## **CLOVER CREEK: High-Hazard Pipeline Construction**

Examination of the available plans for construction of the Atlantic Coast Pipeline (ACP)<sup>1</sup> in the Clover Creek area reveals significant deficiencies in the Draft Environmental Impact Statement (DEIS) published on 12/30/16 for the proposed project by the Federal Energy Regulatory Commission (FERC). The DEIS does not satisfy the requirements of the National Environmental Policy Act (NEPA). As indicated in the following points, the DEIS fails to address a number of substantive environmental issues, and it allows deferral of critical analysis and plan submission.

**Figure 1** - Clover Lick Mountain, Pocahontas County, West Virginia

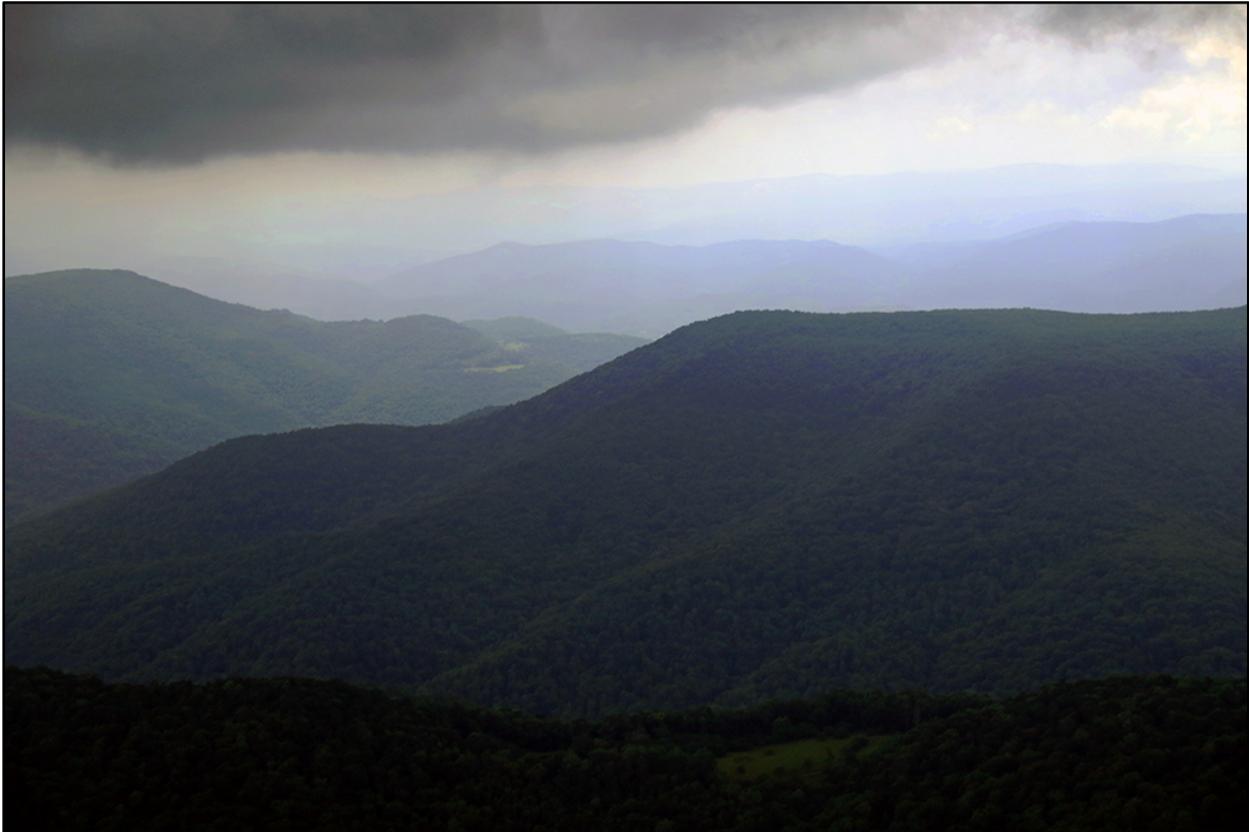
- The proposed Atlantic Coast Pipeline would cross Clover Lick Mountain (4,000 feet), descend into the upper headwater area of Clover Creek, and ascend Gibson Knob (4,400 feet) on the ridge in the foreground of Figure 1. Extensive access road construction on steep slopes will also be required in this area.
- The Clover Creek, Clover Lick Mountain, and Gibson Knob area presents extreme challenges for pipeline construction due to steep slopes, high-excavation requirements, highly erodible and slip-prone soil, and the presence of interconnected karst ground water. The same risk factors are present at many other locations along the proposed ACP route.
- Although the Draft Environmental Impact Statement (DEIS) did not provide site-specific erosion and sediment control (ESC) plans or detailed information on slope stabilization, Atlantic has

**Figure 2 – Proposed pipeline construction in the Clover Creek area (steepness)**

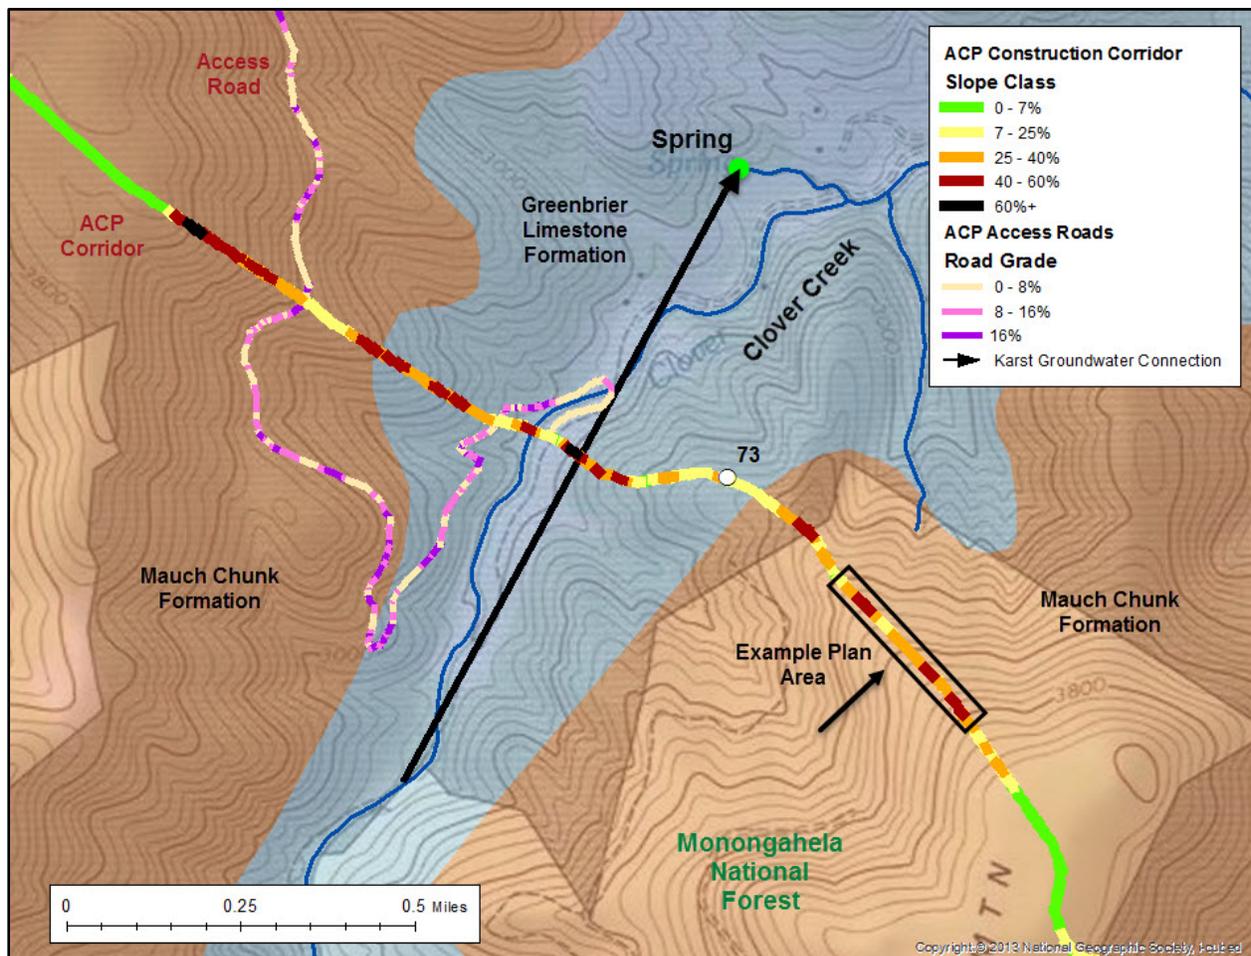
- Figure 2 shows the location of the primary 125-foot-wide pipeline construction corridor (not including additional workspace and stockpile areas), the location of new access road, the location of the 0.3-mile example plan area, and critical environmental factors.

- Construction corridor steepness is indicated in Figure 2 as percent slope, with slope classes based on requirements for spacing of cross-corridor water diversions or slope breakers, which are crucial ESC structures designed to intercept runoff and direct it off of disturbed areas before it has a chance to concentrate, run down the corridor, and cause erosion and off-site sediment transport. Virginia ESC requirements specify placement of slope breakers at 25-foot intervals for slopes of 40% or greater.<sup>5</sup> West Virginia ESC requirements specify placement of slope breakers at 75-foot intervals for slopes greater than 25%, but acknowledge that installation is difficult on slopes greater than 35%.<sup>6</sup> A substantial part of the ACP construction corridor, including in the Clover Creek area, has slopes exceeding 40% where installation of slope breakers is not practicable. Atlantic's methods for controlling runoff on such steep slopes has not been disclosed to the public. Preliminary examination of limited ESC diagrams provided on 3/24/17 for example plan areas raises further concerns about installation of slope breakers on steep slopes, given complications associated with excess spoil and proposed waivers of open-trench limits.

- Access road steepness or gradient is indicated in Figure 2 as percent steepness. The classification is based on guidance developed by the Forest Service to minimize environmental effects of oil and gas roads. This guidance calls for closely following contours to the extent possible, and it states that: *"In mountainous or dissected terrain, grades greater than 8 percent up to 16 percent may be permissible with prior approval of the surface management agency."*<sup>7</sup> Most of the proposed access road in the Clover Creek watershed exceeds 8%, and much of it exceeds 16%. In accordance with the cited guidance, construction of this access road would be prohibited or only allowed after study and planning by an interdisciplinary expert team.

**Figure 3 – Proposed pipeline construction in the Clover Creek area (excavation)**

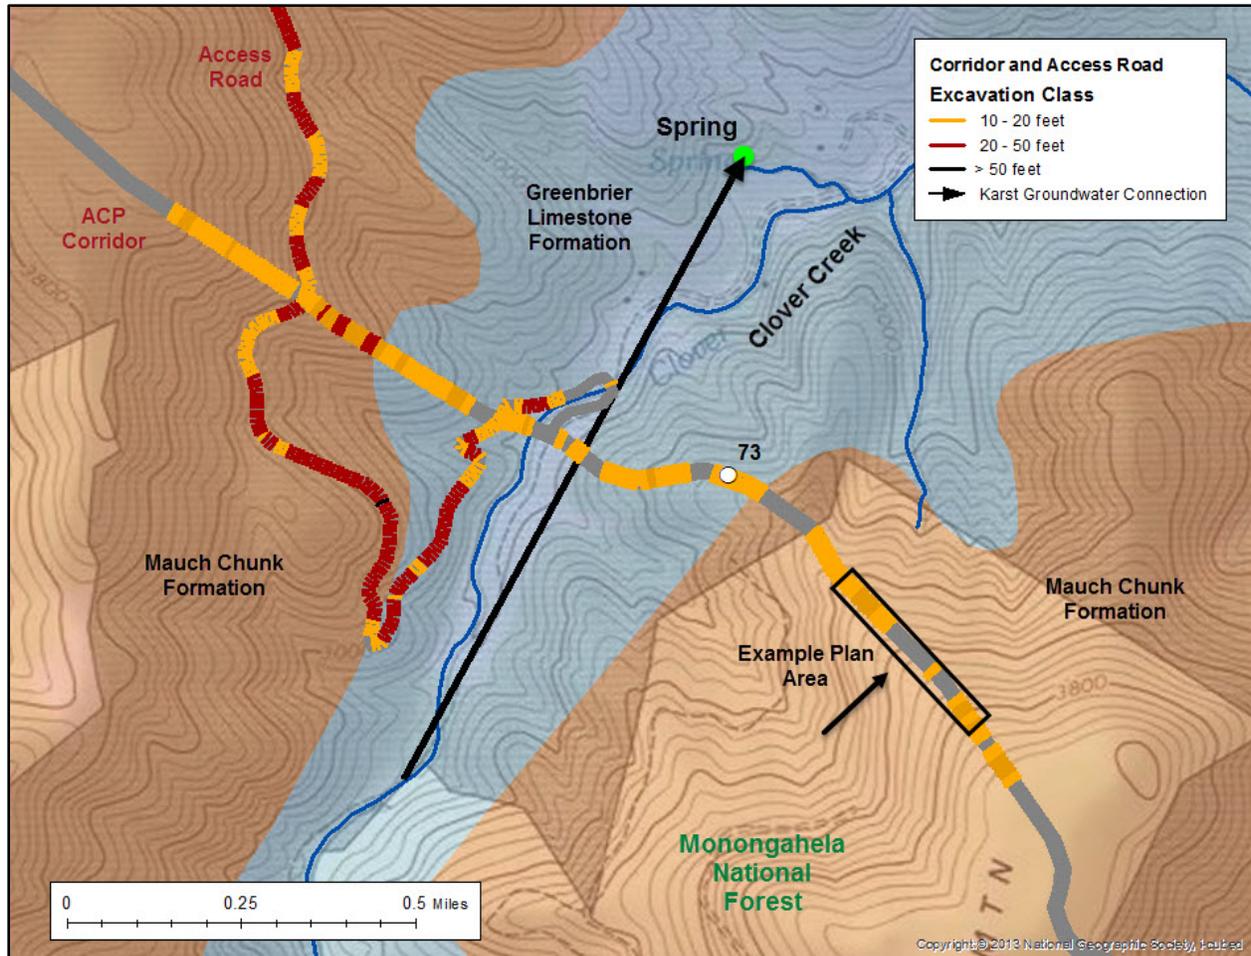
- Figure 3 identifies high-excavation areas of the proposed pipeline and access road construction corridors. The indicated classes are based on the depth of earth material that may need to be removed to cut the original land surface down to a level construction area width of 125 feet for the pipeline corridor and 40 feet for the access road corridor. Much of the proposed pipeline and access road construction in the Clover Creek area will involve steep slopes and high levels of excavation. Specific information concerning the disposition and stabilization of excess spoil has not been provided.

- Much of the high-excavation and steep-slope construction in the Clover Creek area will involve the Mauch Chunk formation. The shales and siltstones of the Mauch Chunk form expansive-clay soils that are highly erodible, producing a suspension of clay-sized particles that are slow to settle-out from runoff and receiving waters. The Mauch Chunk also has the highest potential for slippage of any geology found on the Monongahela National Forest (MNF).<sup>8</sup> Large-scale excavation involving Mauch Chunk soils on steep slopes above and adjacent streams thus presents a high risk of environmental damage and violation of water quality standards. Questions were submitted to FERC during the NEPA scoping period concerning the effectiveness of available Best Management Practices (BMPs) for mitigating pipeline construction impacts in extreme geophysical conditions.<sup>9</sup> FERC did not address these issues and questions in the DEIS.

**Figure 4 – ACP routing across the Mauch Chunk and Greenbrier Limestone formations**

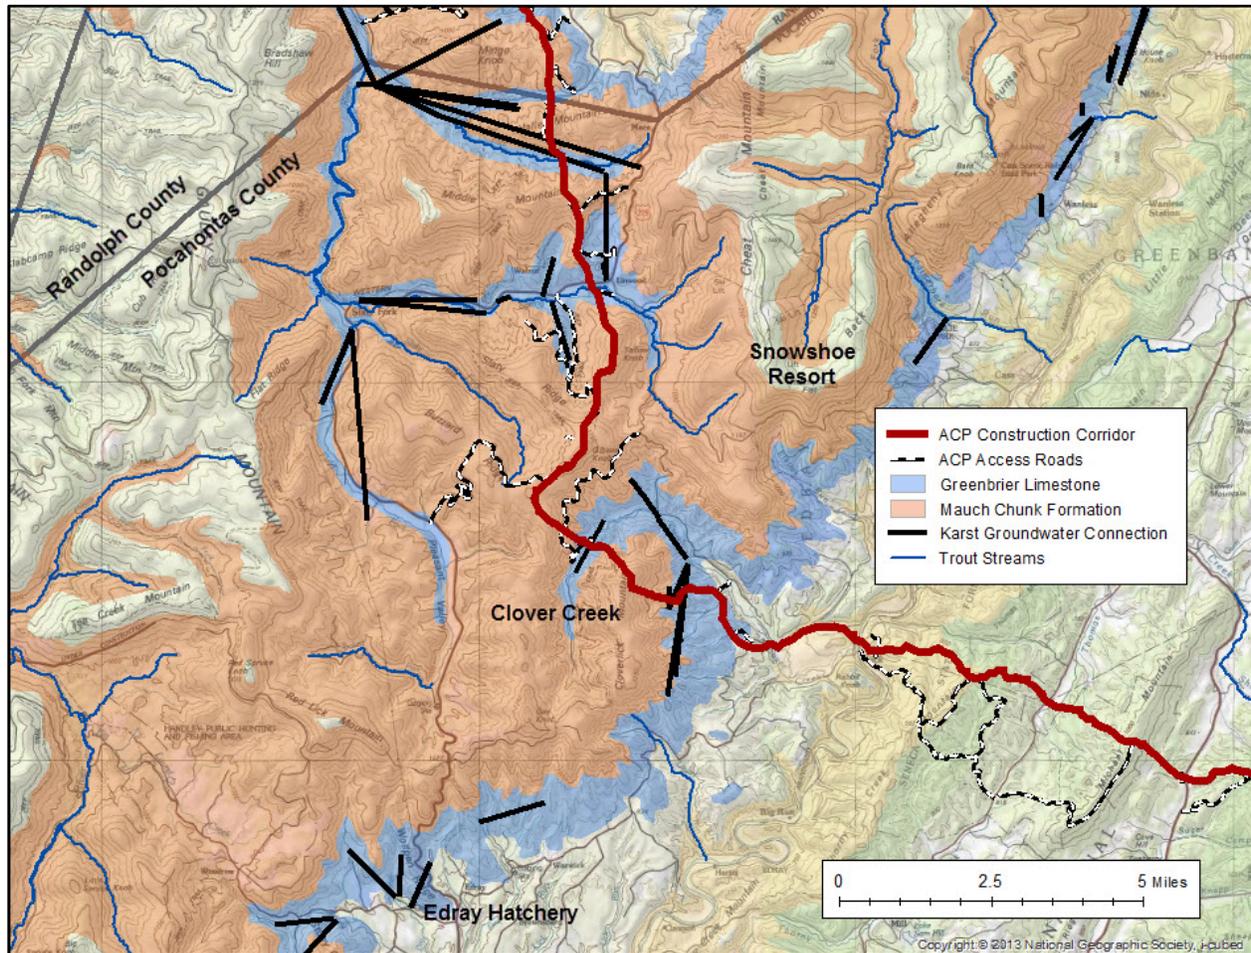
- As indicated in Figure 4, the proposed ACP crosses a large region of Mauch Chunk and Greenbrier Limestone. A number of dye traces have been conducted in this region, including many that have

shown karst groundwater connections in areas that will be crossed by the pipeline.<sup>14</sup> Previous experience indicates a risk of karst system contamination and reduced spring flows following large-scale earth disturbance in or adjacent to karst terrain. During construction of the Highland Scenic Highway in the late 1970s the major spring that supplies water to the Edray Trout Hatchery, was contaminated by suspended sediment, resulting in a large fish kill and reduced spring yield.<sup>15</sup> In this case, sediment-laden drainage from highway construction on the Mauch Chunk travelled two miles before emerging in springs associated with the Greenbrier Limestone, first by surface water in two sinking streams and then via subsurface flow passing under a topographic divide. Construction of the proposed ACP and related access roads will affect multiple locations with similar geology and hydrology in western Pocahontas County and in other karst areas in the path of the proposed pipeline. The DEIS does not address the associated risk of significant damage to water supplies and dependent aquatic ecosystems.
